ADDENDUM NO. 2

Notice to All Persons and Firms Proposing
to Submit a Bid or Furnish Materials for
Mason Road Bridge No. 211
St. Louis County Project No. AR-1133
Federal Project No. STP-5574(604)

MASON ROAD BRIDGE NO. 211

MASON ROAD BRIDGE NO. 211 OVER SMITH CREEK
 END BENT NO. 2
 PLAN & ELEVATION

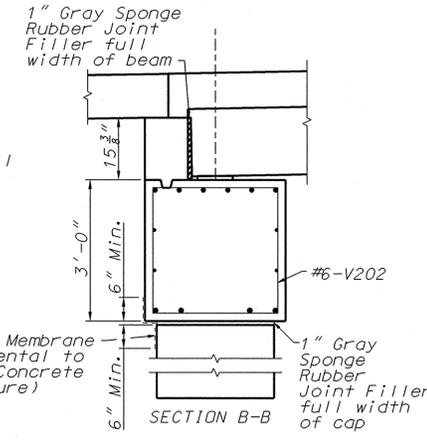
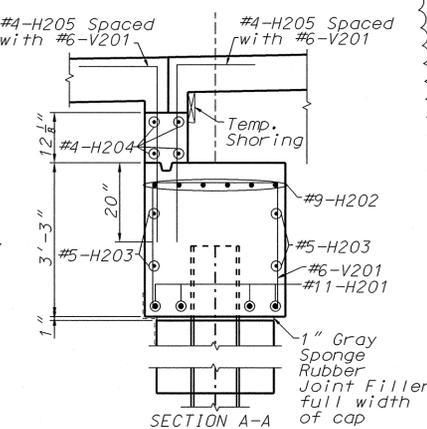
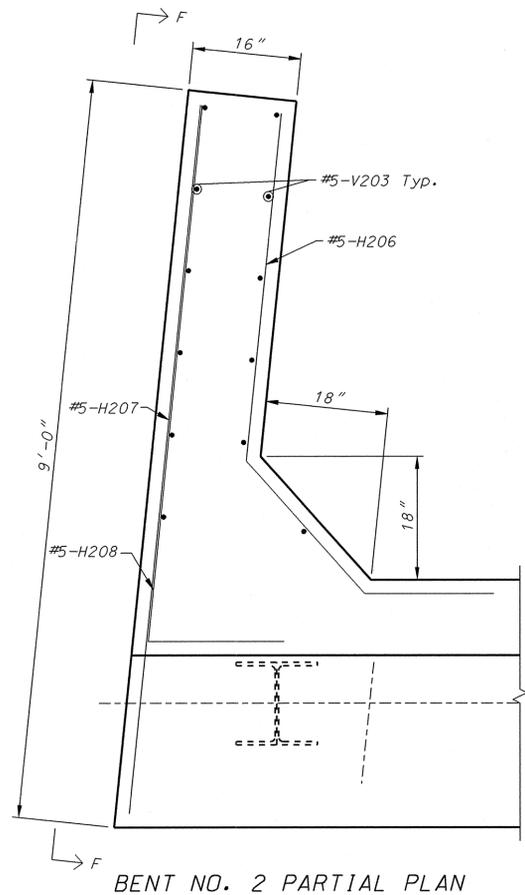
Updated for Superelevation

MASON ROAD BRIDGE NO. 211 OVER SMITH CREEK SAFETY BARRIER CURB SLIP FORM OPTION

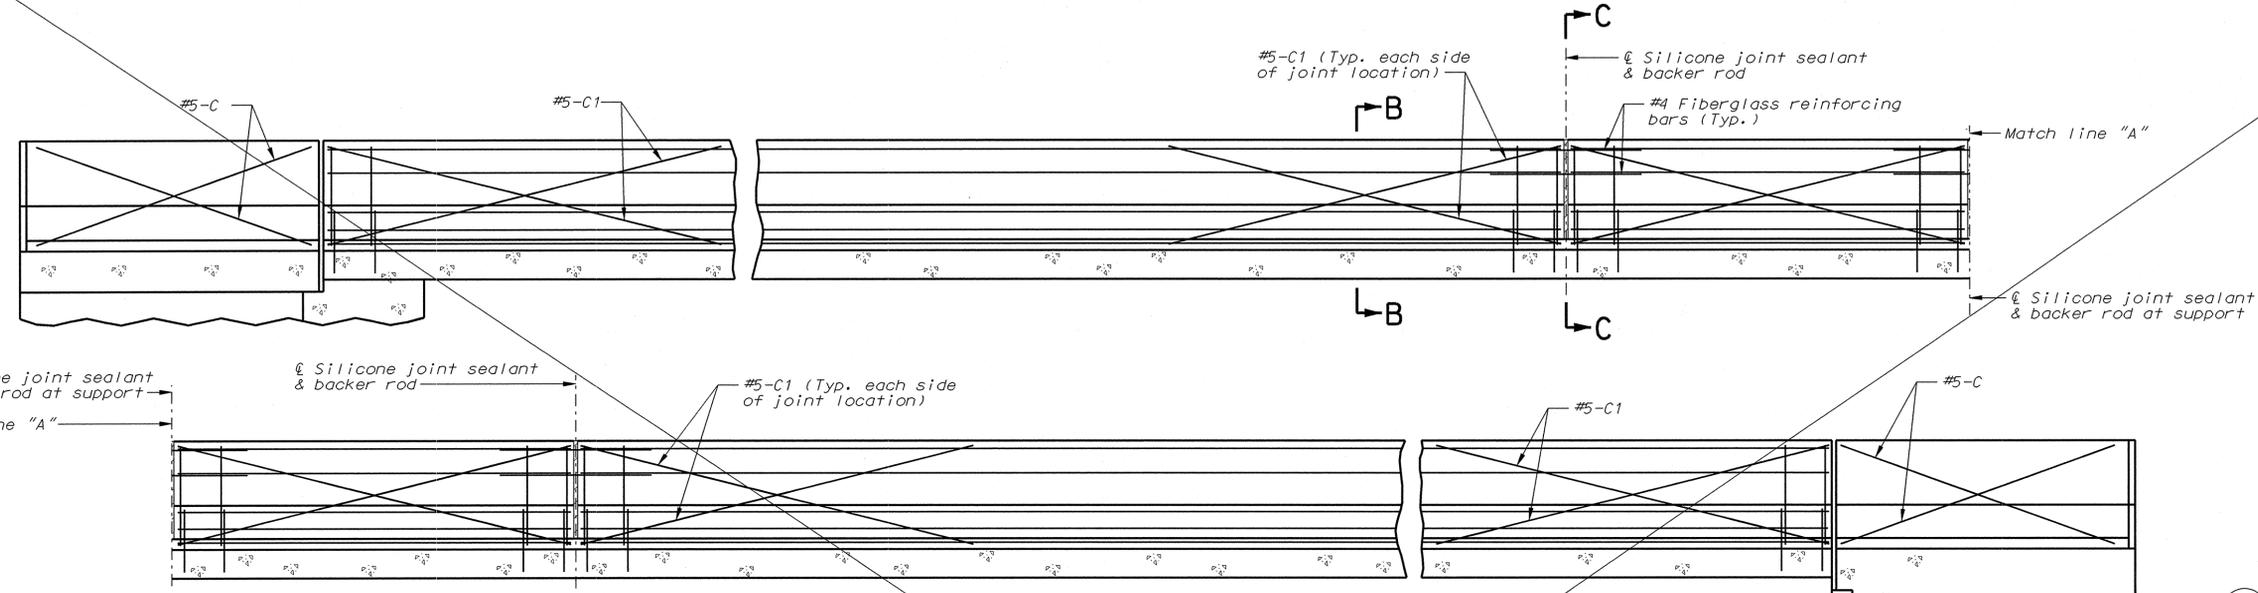
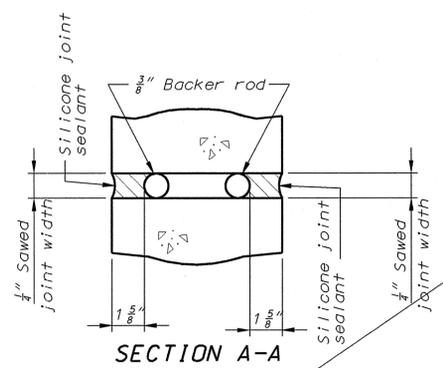
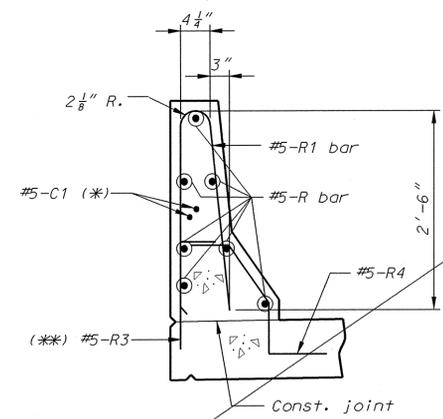
Sheet Deleted
